TECHNICAL EVALUATION REPORT

EQUIPMENT ENVIRONMENTAL QUALIFICATION

DAIRYLAND POWER COOPERATIVE
LA CROSSE BOILING WATER REACTOR

NRC DOCKET NO. 50-409

Figure A-1. Design Basis Accident Pressure and Temperature as a Function of Time

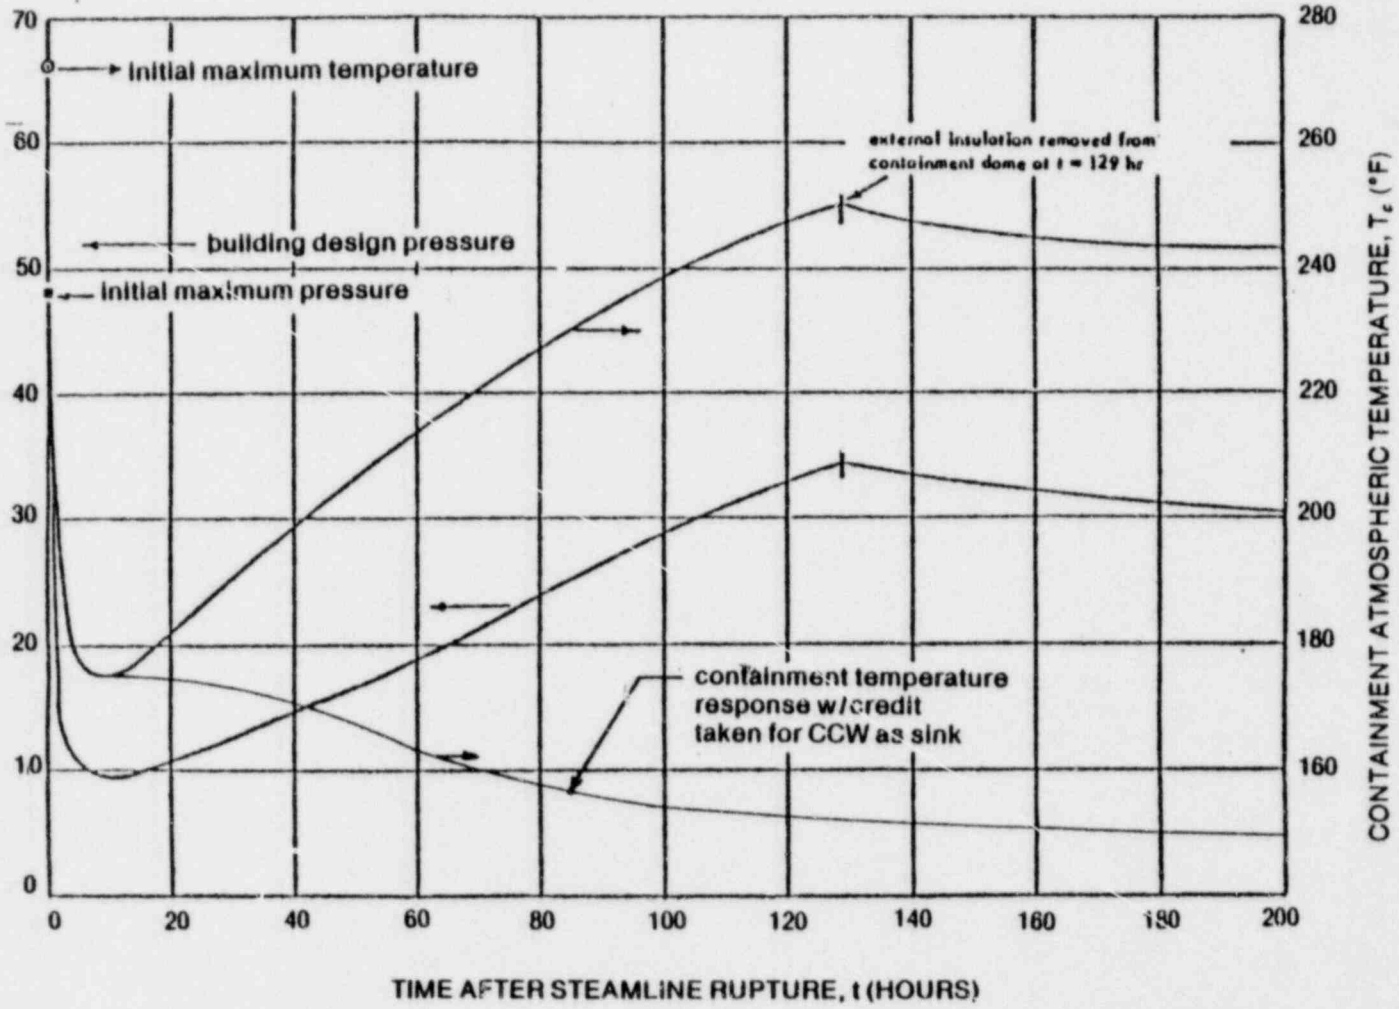
The environmental service conditions for temperature and pressure inside containment are shown on Figure A-1. It should be noted that the high temperature and pressure values on the higher profile envelope curve do not decrease significantly with time after a postulated accident. The Licensee was reviewing this condition with the expectation of providing an alternate safety-related containment cooling mechanism. The final Licensee information submittal [23] presented general data (depicted on Figure A-1) for the containment temperature profile under conditions that would exist if the component cooling water system was employed to achieve long-term cooldown.
